# Coaxlink

## Flash EEPROM Change Note

**1629 Coaxlink Duo PCIe/104-EMB**  
**1633 Coaxlink Quad G3**  
**1633-LH Coaxlink Quad G3 LH**

**1634 Coaxlink Duo PCIe/104-MIL**  
**1635 Coaxlink Quad G3 DF**  
**1637 Coaxlink Quad 3D-LLE**

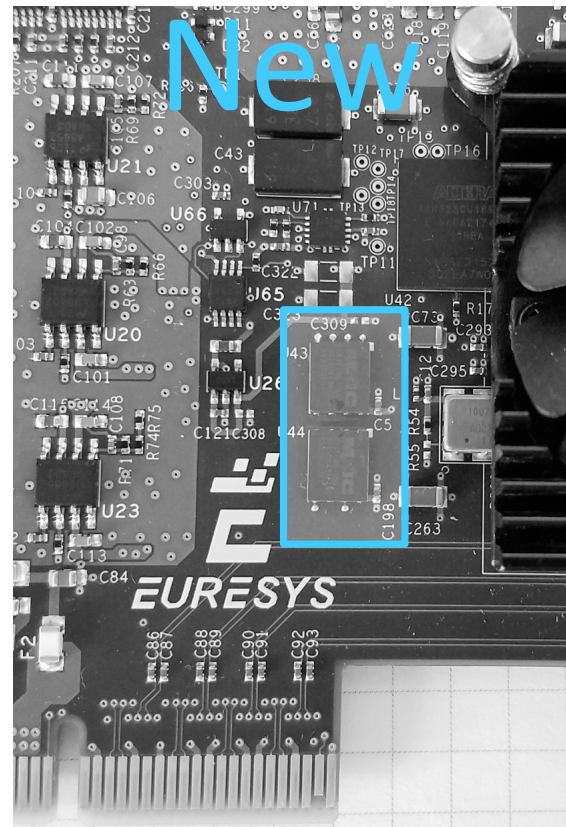
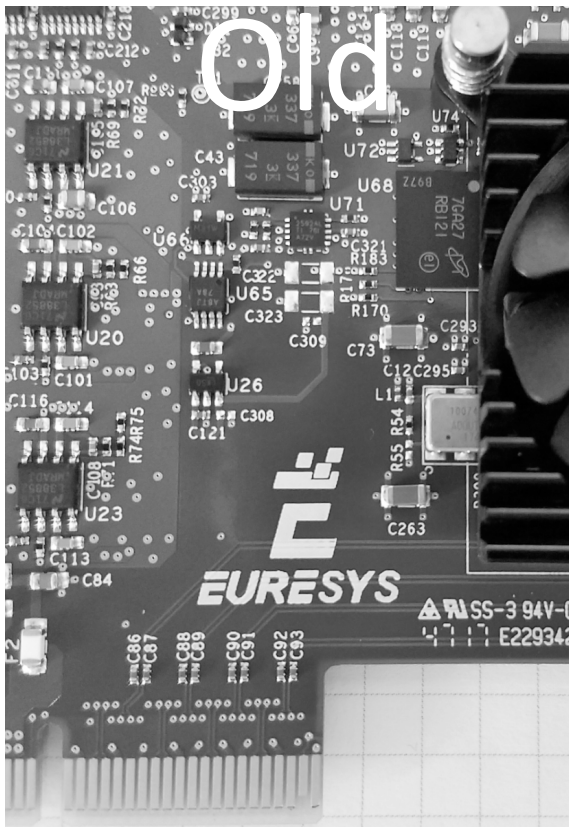
New **1633 Coaxlink Quad G3**, **1633-LH Coaxlink Quad G3 LH** and **1637 Coaxlink Quad 3D-LLE** can be visually identified by the two SPI Flash Memory IC's located between the fan and the PCI Express connector.

See the blue rectangle in the following drawing:
